NCUTCD Approved Changes to the Manual on Uniform Traffic Control Devices

19B-MKG-02

Pavement Marking Standards for Automated Driving Systems
and Improved Driving Safety

Sections 3A.06, 3B.04 and 3B.05 related pavement marking
width, pattern and standardization

Figure 3B-8. Examples of Dotted Line and Channelizing Line Applications for Exit Ramp Markings (Sheet 1 of 2)

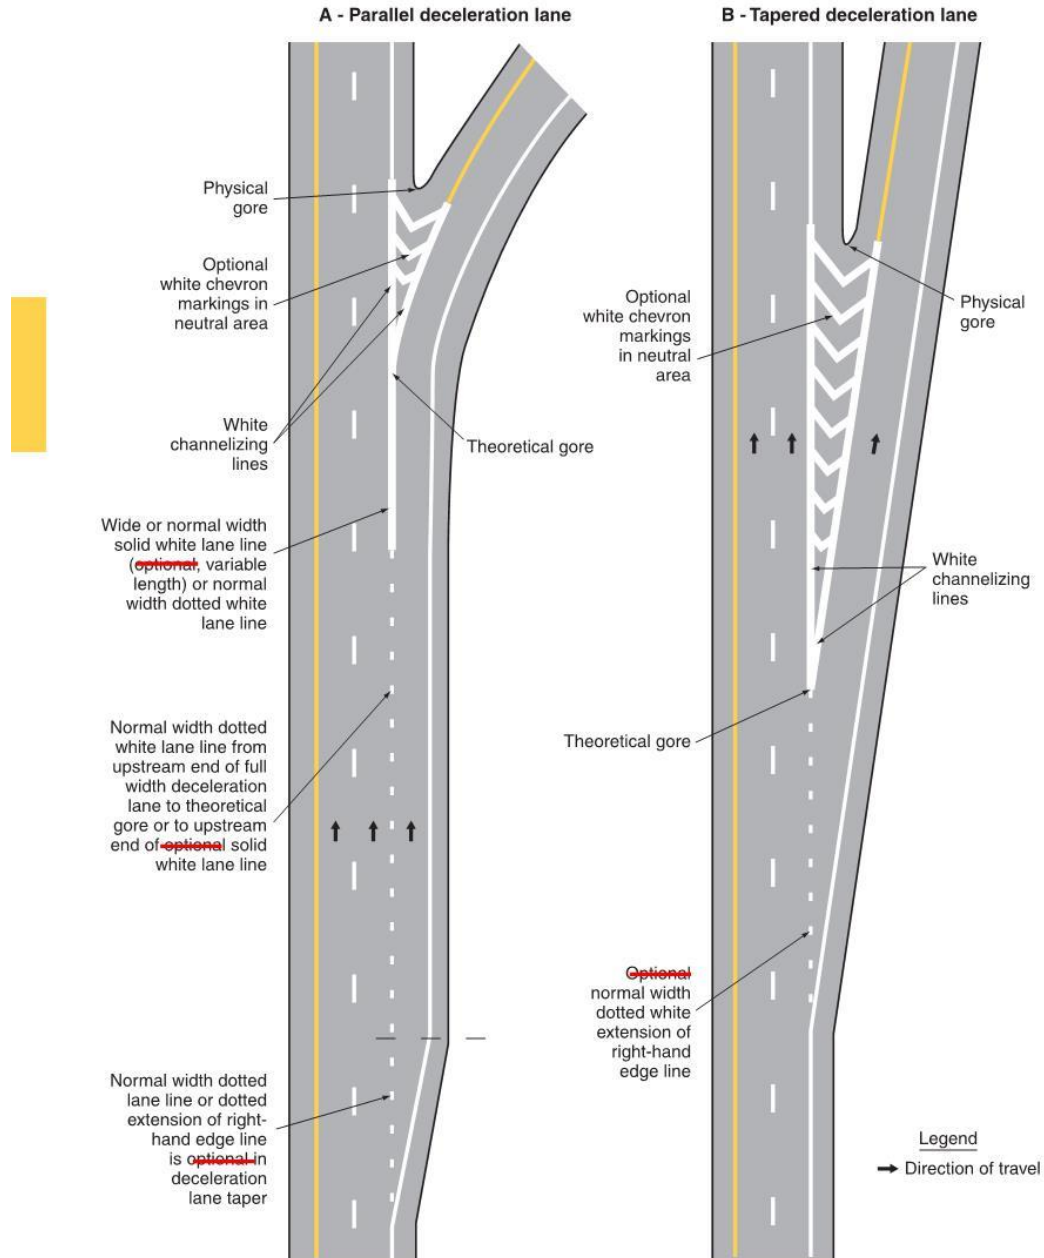
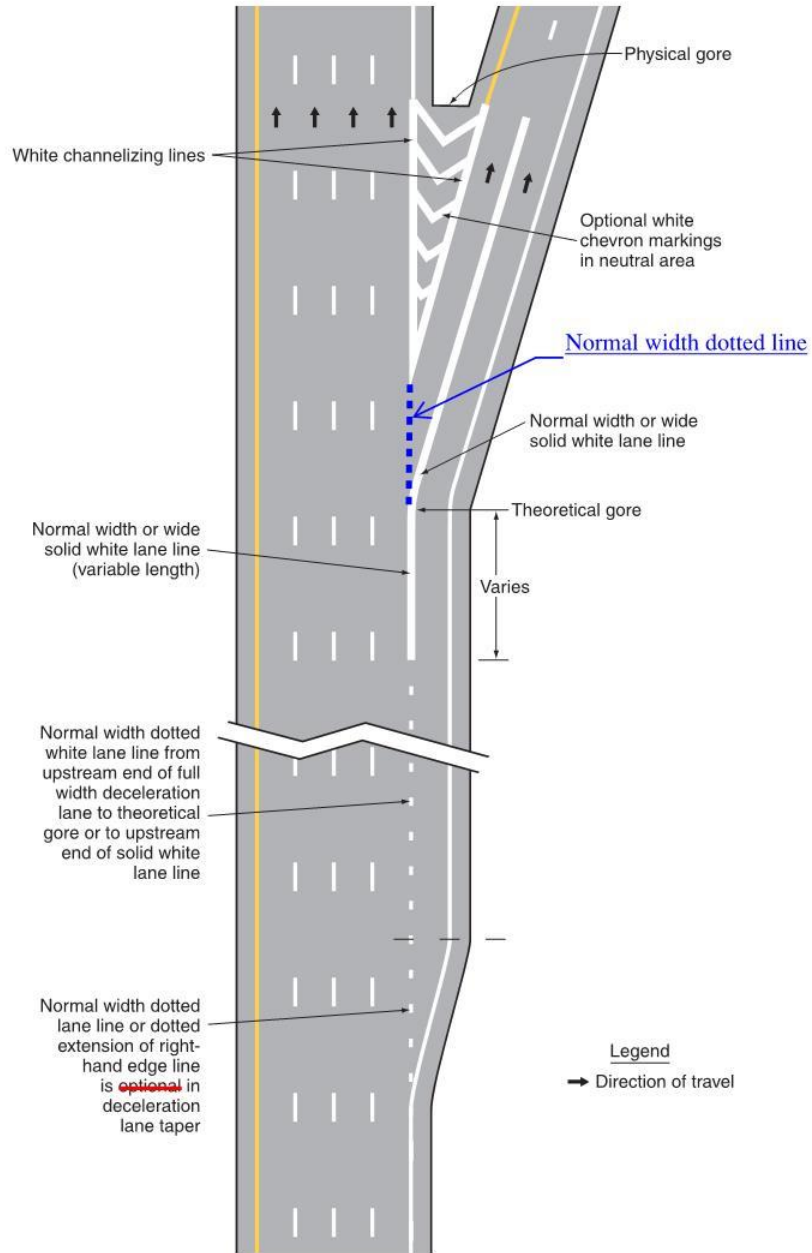
222 07 For exit ramps with a parallel deceleration lane, a normal width dotted white lane line
223 **extension** shall be installed from the upstream end of the **taper full-width-deceleration lane**
224 to the theoretical gore or to the upstream end of a solid white lane line, if used, that extends
225 upstream from the theoretical gore as shown in Drawings A **and or** C of Figure 3B-8.

230 09 For an exit ramp with a tapered deceleration lane, a normal width dotted white line
231 extension ~~may~~ **shall** be installed from the theoretical gore through the taper area such that
232 it meets the edge line at the upstream end of the taper as shown in Drawing B of Figure 3B-
233 8.

323 [In the following Figures, remove the word “optional” for the dotted edge line extensions
324 through the exits and entrances.]
